Killarney Cycle Lanes

Part VIII

Submission Document

FEBRUARY 2021

The pedestrian crossing on the Park Road immediately after the roundabout should be modified.

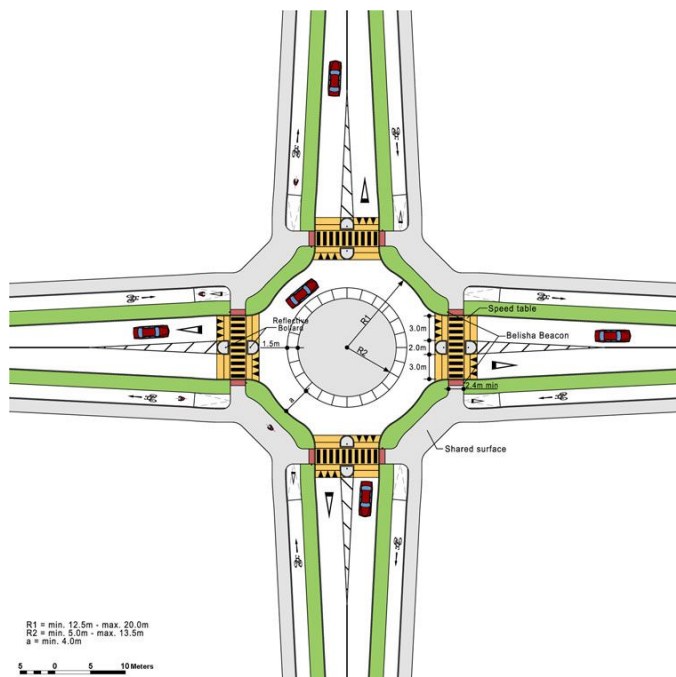
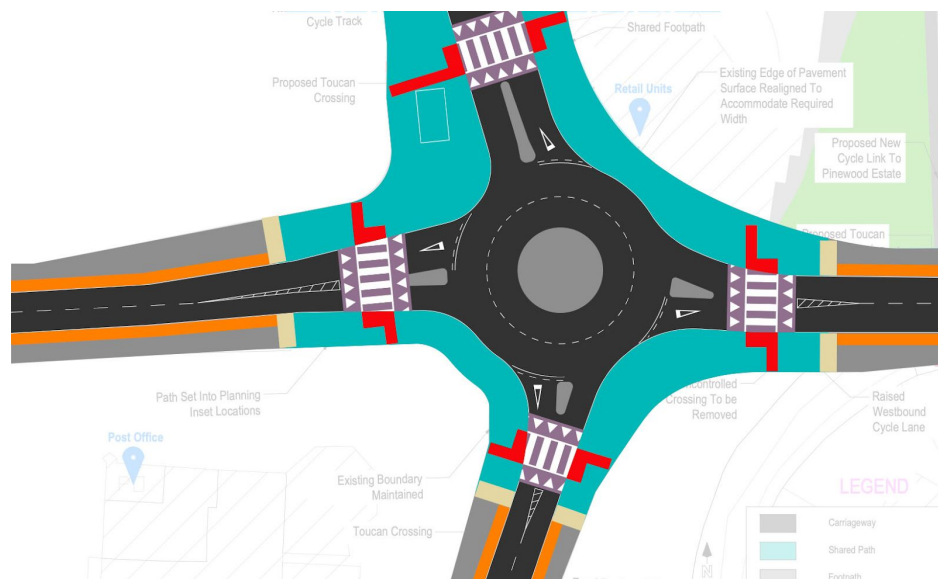
- Vehicle lanes on both sides should be significantly reduced. As designed now, the vehicle lanes on the roundabout side of the crossing point splay out and this will result in much higher, dangerous, speed of vehicles approaching the crossing. Minimise the width as much as possible
- Utilise the additional space to create a pedestrian/cyclist refuge in the middle of the lanes
- Widen the crossing to 6m minimum
- Utilise a tabletop design with a colour contrast finish

CYCLOPS JUNCTION

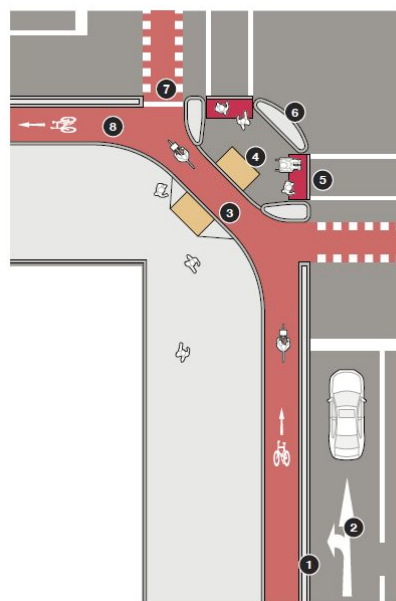
The proposed junction design is unsafe for young, elderly and novice cyclists. A more effective and safe design would be the Cycleops Junction as shown below. It is more efficient for pedestrians, cyclists and vehicles.

- Pedestrians and cyclists all move on one shared green phase, and vehicles in separate phases
- Vehicles should be held well back from the junction to ensure no encroachment onto the pedestrian and cycle crossing points
- Pedestrians use refuge islands to cross and are separated from cyclists at the crossing points
- The design has a higher vehicle capacity than the current Part VIII plan

Railway Bridge

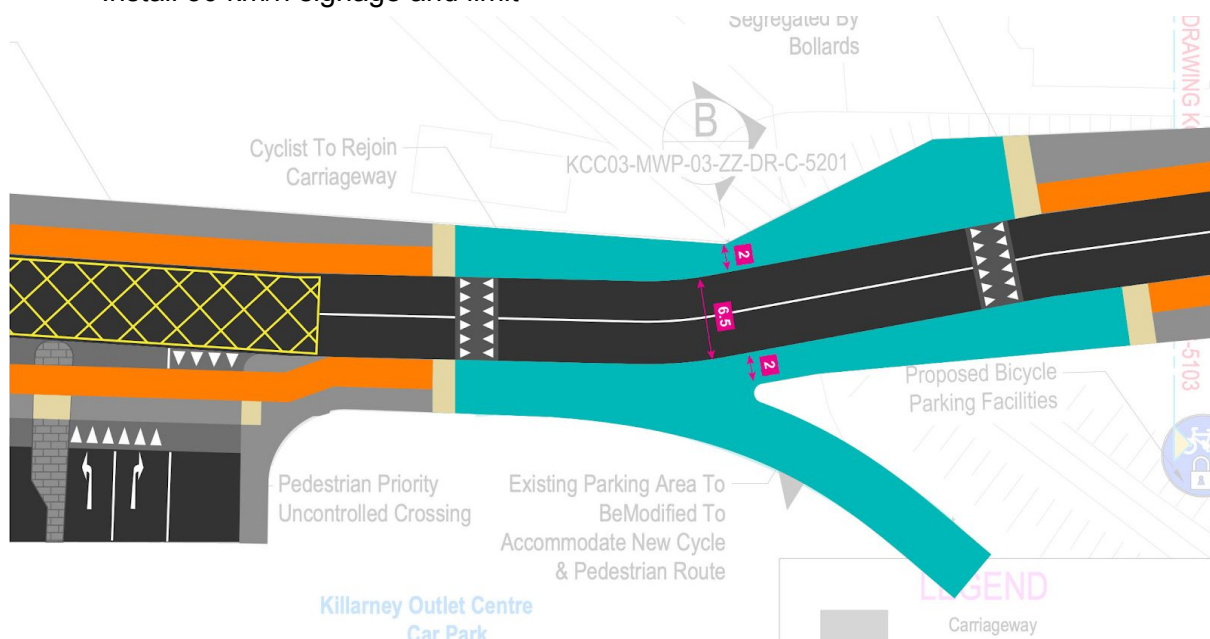
Understanding that this is a complicated pinch point, we suggest the following changes to ensure continuity in the scheme.

- Narrow the vehicle lanes on approach to the minimum permissible to make space for a new shared path. In our proposed design we have suggested a shared path on the southern side, but this may not be required as the underpass option which continues into the outlet centre car park may be more suitable and attractive. Space saved could be utilised on the northern side of the railway bridge shared path as proposed
- Install speed control ramps in advance of the bridge to slow vehicle traffic
- Install signage/stencilling advising of slow speed requirement for vehicles
- Install 30 km/h signage and limit

Outlet Centre / Bus Station

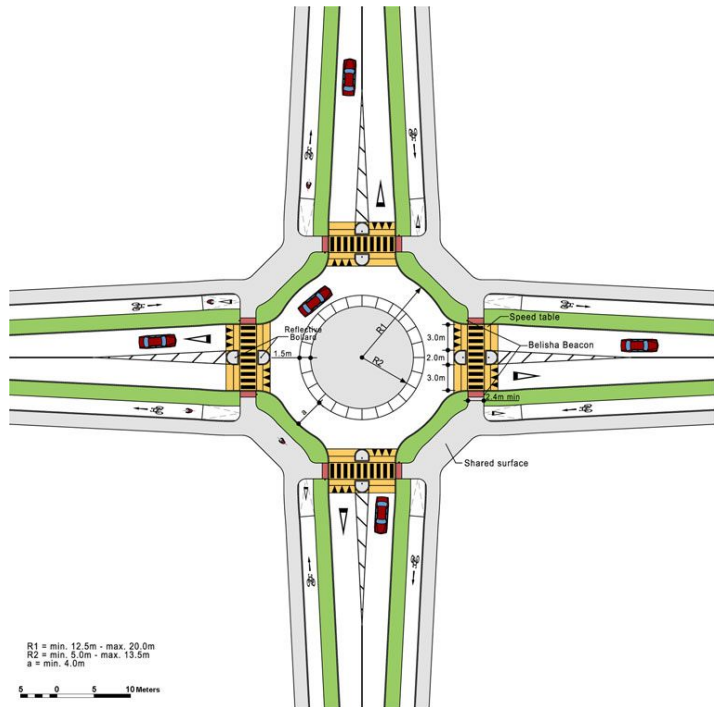
This junction is complicated due to the number of potential simultaneous vehicle movements. The objective here should be to move the cycle lane back from the vehicle turning points on the southern side while fully segregating the northern side. This junction should be considered for upgrade to a fully controlled crossing in future.

- On the northern side, continue the segregated path, but also install a cycle turning refuge area
- On the southern side, set the cycle way back from the road by one vehicle length to reduce the possibility of obstruction by a turning vehicle
- Ensure corner radii are acute

- Reduce car park exit from two vehicle lanes to one and utilise the reclaimed space to create a cycle access route to the outlet centre and bus station
- Where the cycle path crosses the outlet centre and bus station entrance/exits utilise a zebra crossing with colour contrast tabletop design of 4m in width

Outlet Centre

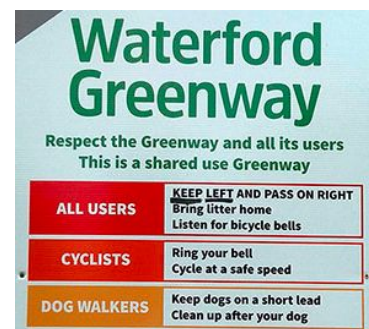
Significant hard measures such as bollards or walls/planters will be required to ensure vehicles are not parked on the Park Road outside the Outlet Centre. This is already a problem and should be tackled as part of this project.

Cleeny Roundabout

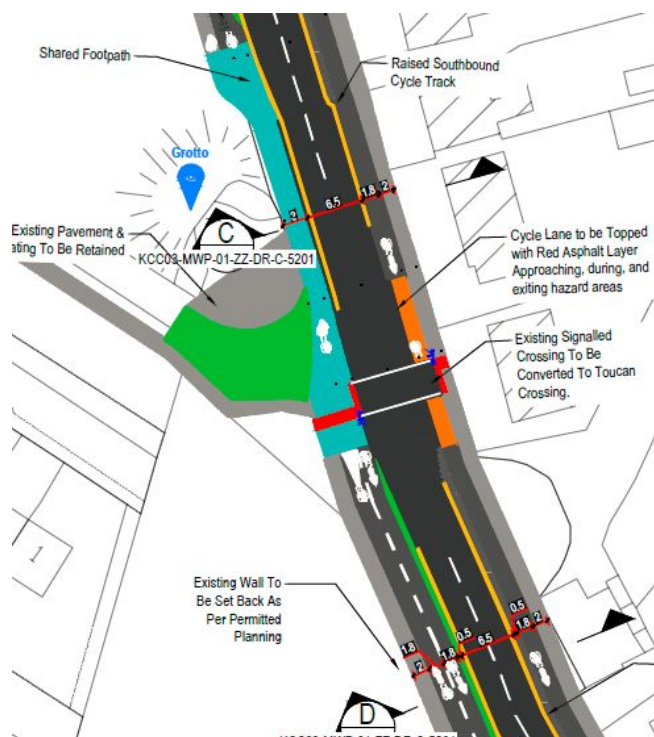
The proposed design does not include any upgrade to the uncontrolled crossing:

- Widen the crossing point to 8 meters
- Utilise a colour contrast tabletop crossing design
- Narrow the entrance and exit vehicle lanes to a minimum (3.0m) to slow traffic
- Remove one vehicle turning lane from the northbound vehicle lane
- Utilise high visibility segregation measures to prevent vehicles from illegally obstructing the cycle lanes

CYCLOPS JUNCTION

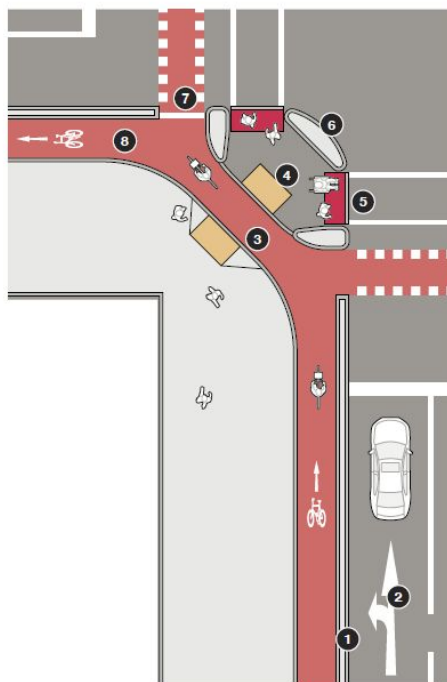
We propose that the junction be revised as a cyclops junction. This would be more appropriate, safer and more efficient for all road users due to the very busy nature of the junction. The liberal use of shared space in the present design will result in unnecessary conflict between people walking and those on bicycles. Additionally, the parking spaces on the south-western side of the junction should be made parallel.

Two-Way Cycle Track

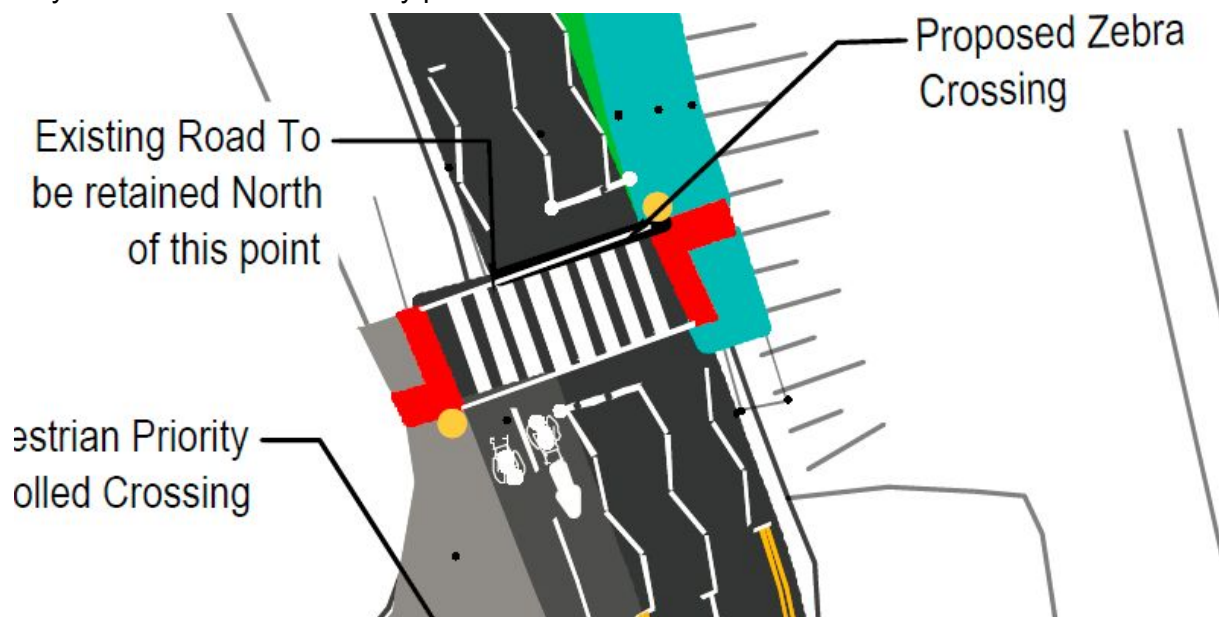
We wish to commend the council on the brave decision to request the stadium wall to be set-back to allow space for the cycle track. We propose that the use of a fully segregated cycle track be looked at on both sides of the road instead of the proposed two-way design. Understanding that the purchase of residential gardens could delay this project, the two-way design may be more effective as an initial measure.

Whichever design is deemed more appropriate, significant hard measures are needed to adequately protect the cycle lanes from match day traffic. All sections of the route should be physically segregated and all entry and exit points similarly protected. It would be very unfortunate to install these wonderful cycle tracks only to have them rendered useless to people wishing to cycle to a match.

Fitzgerald Stadium

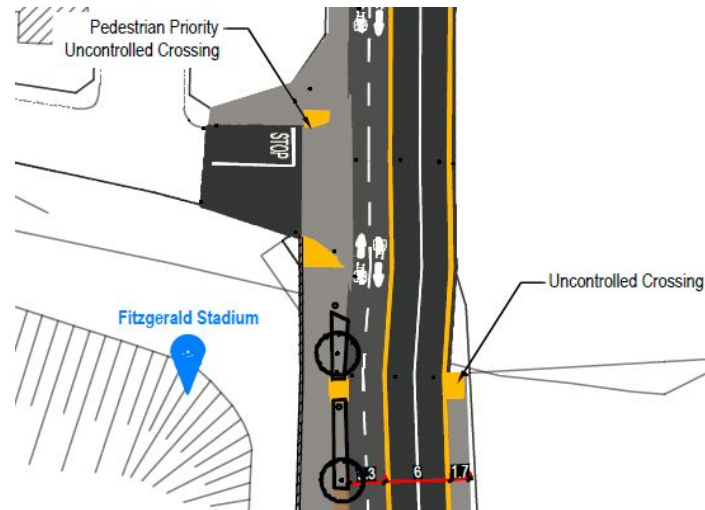
The uncontrolled crossing where the footpath ends should be upgraded to a zebra crossing.

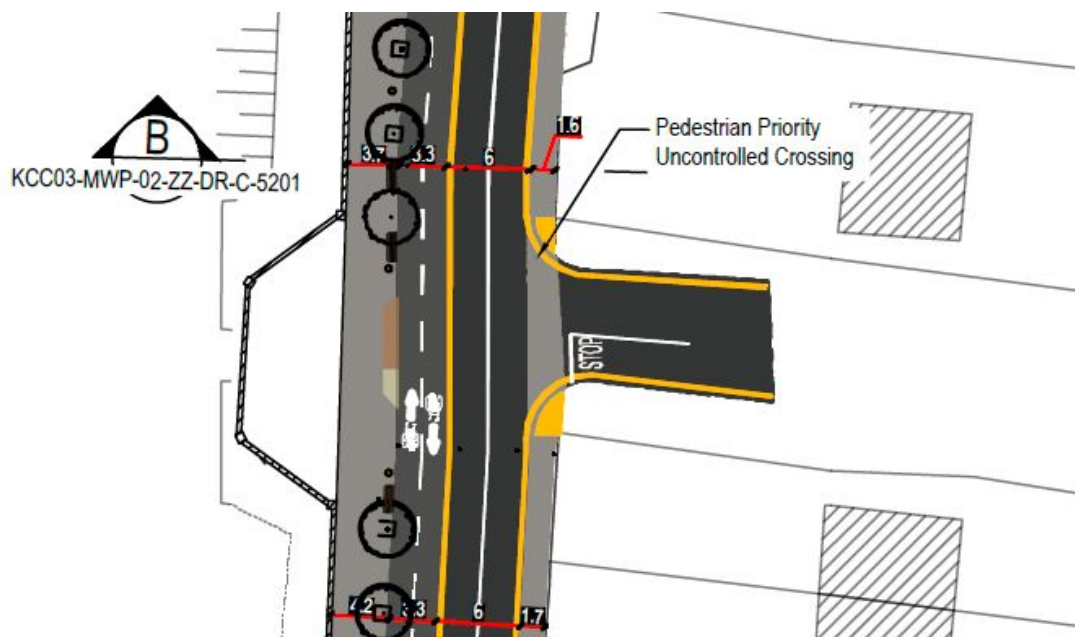
Outside the entrance to the stadium, there appears to be no way for a cyclist to leave the cycle track and cross the road. We suggest crossing be employed here to enable future connectivity to the pitch and putt club and residences in upper Deer Park as part of a future scheme.

Dalton's Avenue

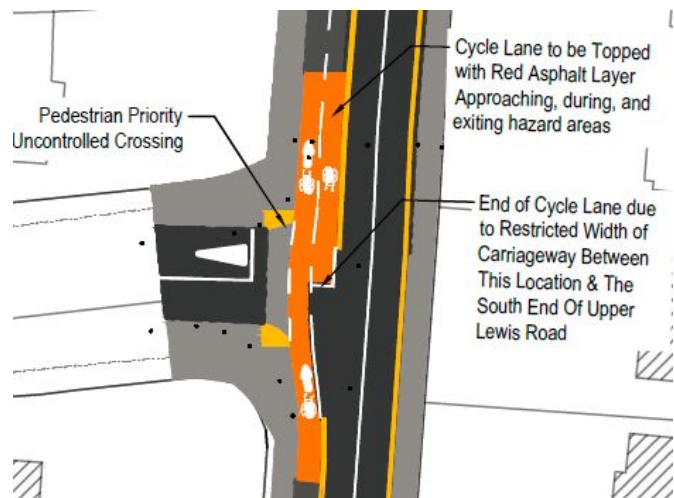
As designed, the two-way cycle track ends in the middle of the junction at Dalton's Avenue. This presents a significant point of conflict between motorists and cyclists. We suggest an alternative design be sought to enable cyclists to transition to the inbound vehicle lane. A controlled crossing point may be desirable. This is one of the key reasons two-way cycle tracks are not recommended in an urban context and again we suggest that a one-way cycle track on each side of the road be employed.

Efficiency, Attractiveness and Parking

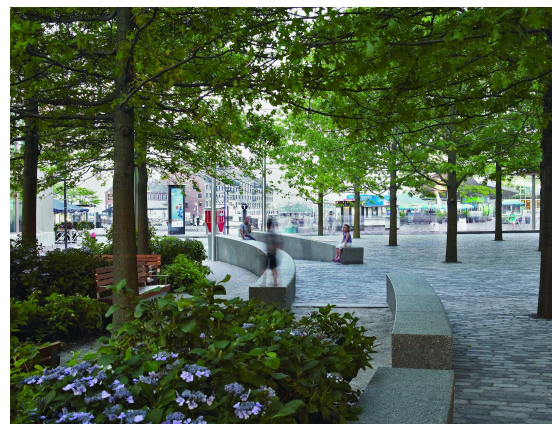
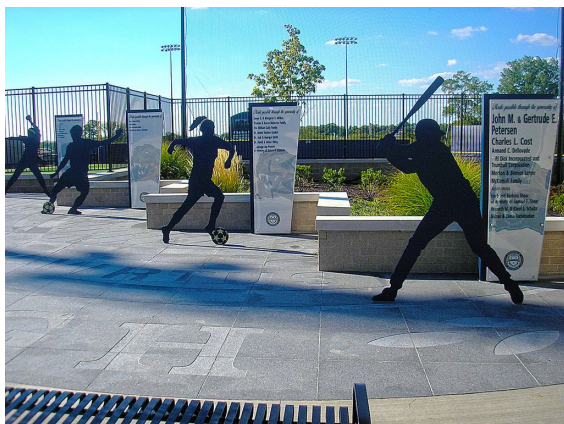
- The efficiency of this part of the project hinges on two areas:
 - a. Protection from illegal parking, particularly on match days, with hard measures
 - b. Transition points for the two-way design back onto the roadway
- The entrance to Fitzgerald Stadium has the potential for a pedestrian plaza. With appropriate planting, public lighting, seating and bicycle parking this could be a very attractive place to enjoy
